**TOWN OF NEWBURGH
PLANNING BOARD
TECHNICAL REVIEW COMMENTS**

PROJECT NAME: UNITY PLACE WAREHOUSE
PROJECT NO.: 21-29
PROJECT LOCATION: NORTHWEST CORNER OF OLD LITTLE BRITAIN RD. & UNITY WAY
SECTION 95, BLOCK 2, LOT 14.1 & 19.12
REVIEW DATE: 15 JULY 2022
MEETING DATE: 21 JULY 2022
PROJECT REPRESENTATIVE: BROOKER ENGINEERING

Unity Place Warehouse Site Plan Application, Town of Newburgh Planning Board
July 6, 2022
Responses to Review Comments
BE #21202

TOWN OF NEWBURGH FIRE PROTECTION
FLOW TO BLDG. CONNECTION DETAIL

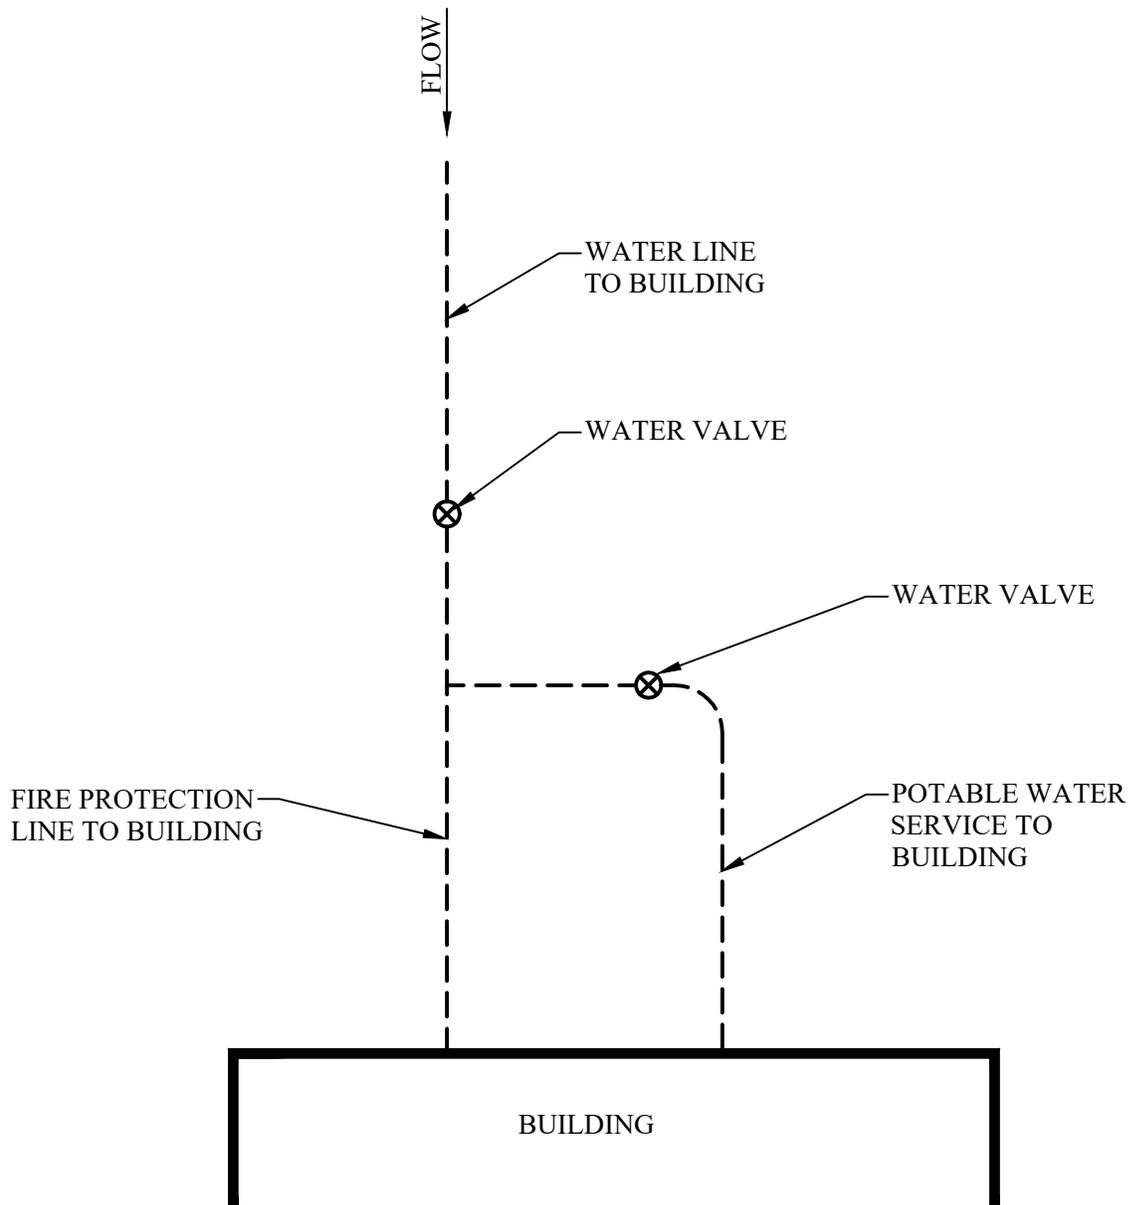
4. Detail for the water line/ fire service is attached to these comments.
5. Standard notes for water and sewer are attached.
6. The applicants have requested to defer the sanitary sewer pump station design until the Planning Board completes its SEQRA review. This may delay any preliminary approvals by the Board.

5. *COMMENT: The water line and fire service line must be installed per Town of Newburgh requirements, where if fire service line is terminated potable water to the building is terminated. Copy of a typical detail is attached.*

NOTE:
 VALVING MUST BE ARRANGED SO THAT
 POTABLE WATER IS TERMINATED IF
 FIRE PROTECTION LINE IS TURNED OFF.

Review of Level Spreader flow path

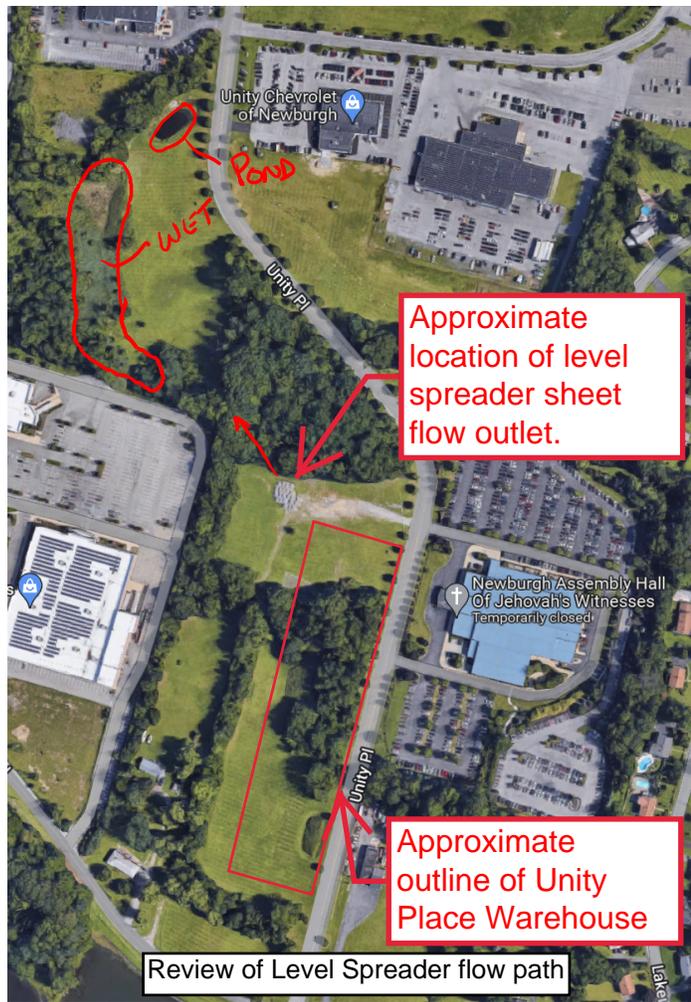
9. *COMMENT: The applicant's representative is requested to identify a location where flared end section 15 discharges to a natural water course. Currently that discharge will be at a point along an adjoining property line.*

Response: The flared end section is followed by a level spreader that is intended to create a sheet runoff outflow that will tend to mimic existing runoff patterns. As requested, imagery of the adjacent property and watercourses is attached.
